UNITED STATES PATENT AND TRADEMARK OFFICE

APPLICATION NO.	FILING DATE	FIRST NAMED INVENTOR	ATTORNEY DOCKET NO.	CONFIRMATION NO.
10/585,665	11/13/2007	Wolfgang Kramer	016906-0524	4196

Office Action Summary	Application No. 10/585,665	Applicant(s) KRAMER, WOLFGANG	
	Examiner Leonard R. Leo	Art Unit 3785

DETAILED ACTION

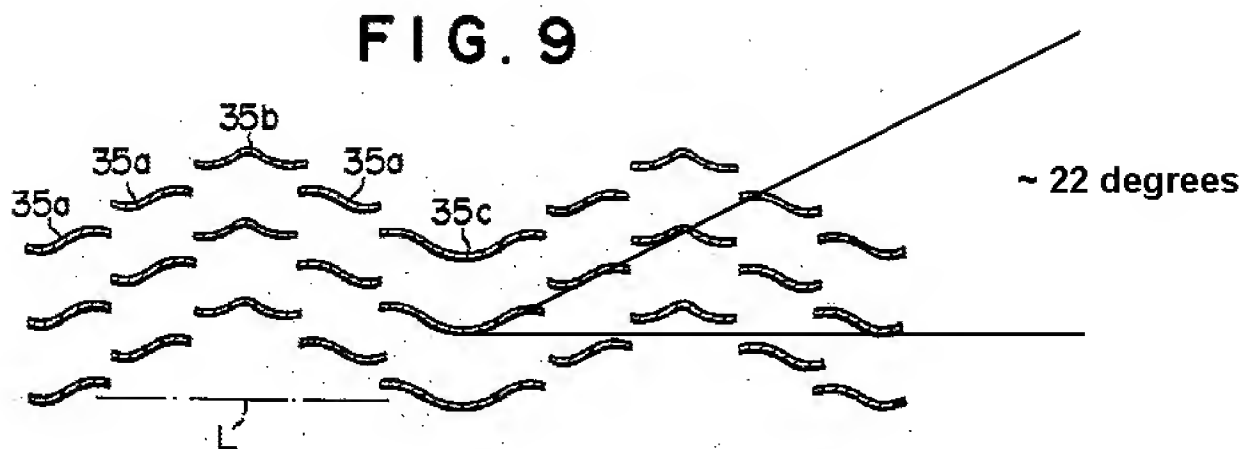
Hatada et al (Figure 10) discloses a fin comprising gills 45 having a S-shaped cross section with an incident-flow angle approximately the same size as a flow-off angle of zero degrees and a deflecting angle of about 22 degrees (as permissibly gleaned from the drawings below), but does not disclose flat tubes.

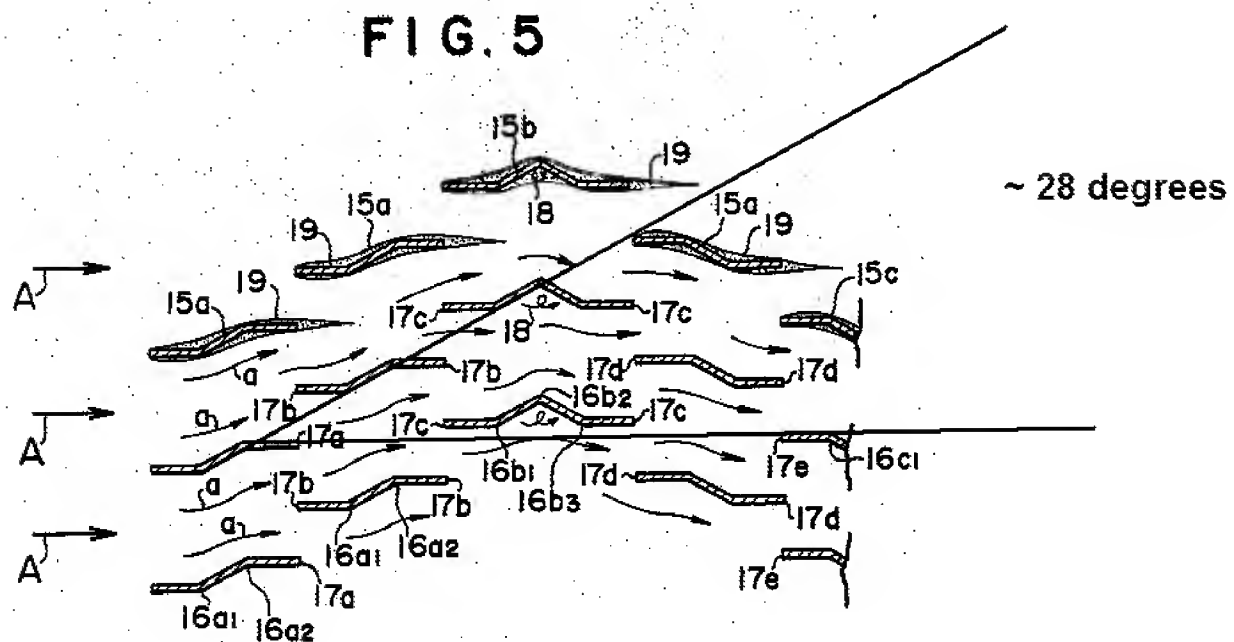
Regarding claims 12-14, Figure 5 of Hatada et al discloses gills 15a, 15c having an approximately Z-shaped cross section with an incident-flow angle approximately the same size as a flow-off angle of zero degrees and a deflecting angle of about 28 degrees (as permissibly gleaned from the drawings below).
